Date: January 6, 2020

From: Henning Larsen, R.G.
Senior Hydrogeologist

Subject: Zenith Energy – Proposed Storm Water Infiltration System
5501 NW Front Avenue, Portland, Oregon 97201

Figure 3 –
Proposed
Development

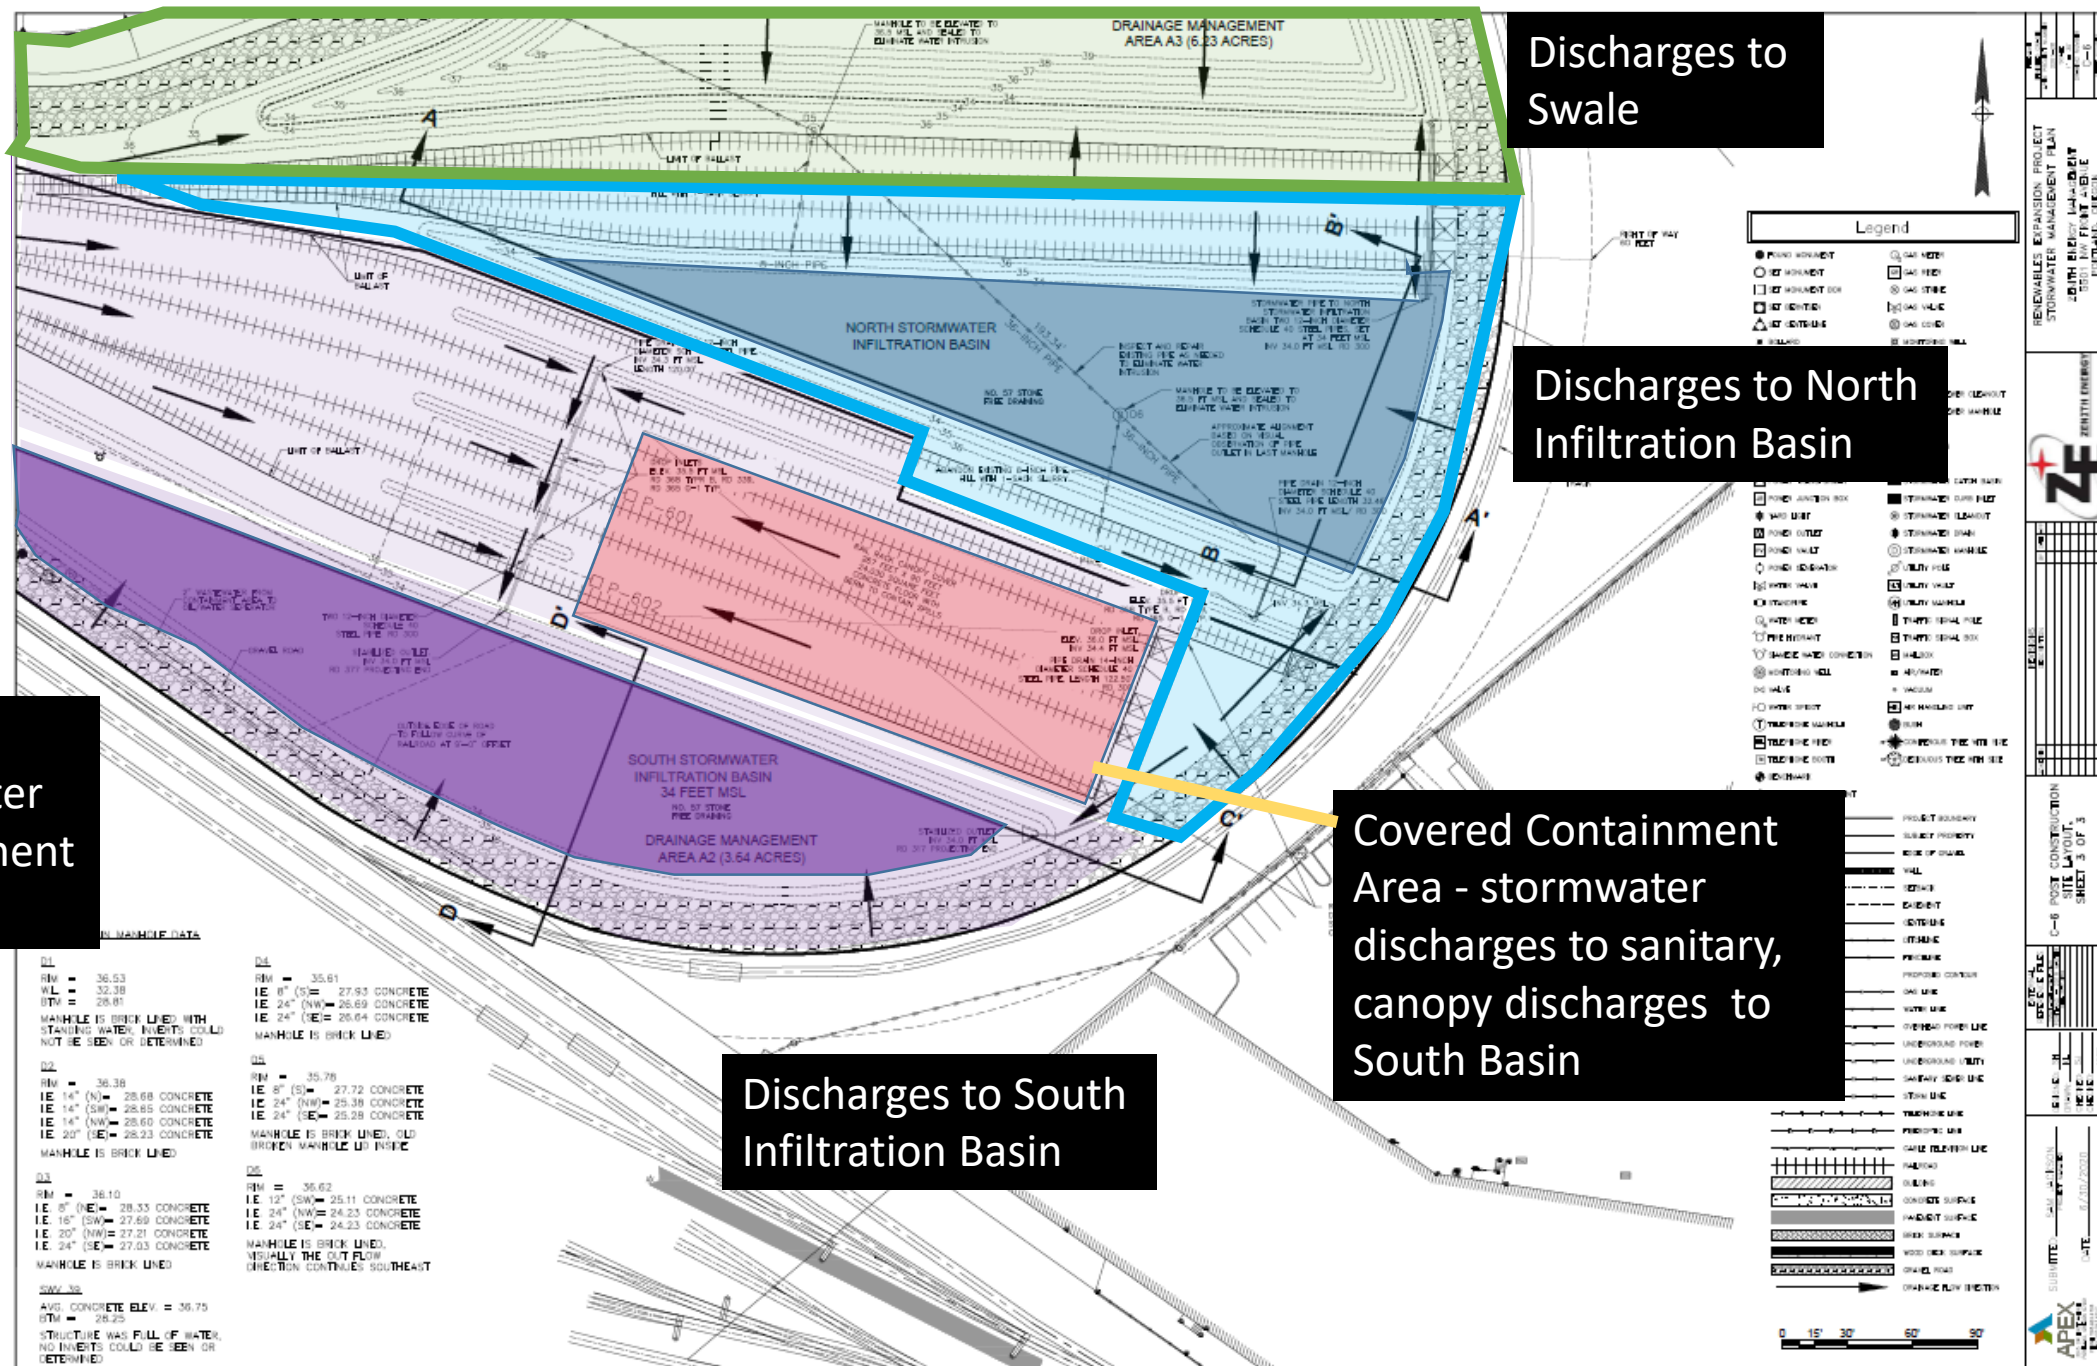
Design plans included in the Groundwater Protection report also indicate overland flow of stormwater from the new rail spurs will discharge to the basins, however, the volume and frequency of the flow is anticipated to be low (See attached Table 1). The quality of this stormwater was not discussed or characterized in the report (i.e. composition of stormwater running off a railyard associated with a petroleum distribution facility).

- The most significant change to the property is the construction of 10 spur rail lines supporting the petroleum distribution facility. These lines will occupy the majority of the undeveloped portion of the property. The impact this development may have on underlying groundwater quality is unknown to me, however, it should be noted this is the current land use immediately west of the Zenith facility.
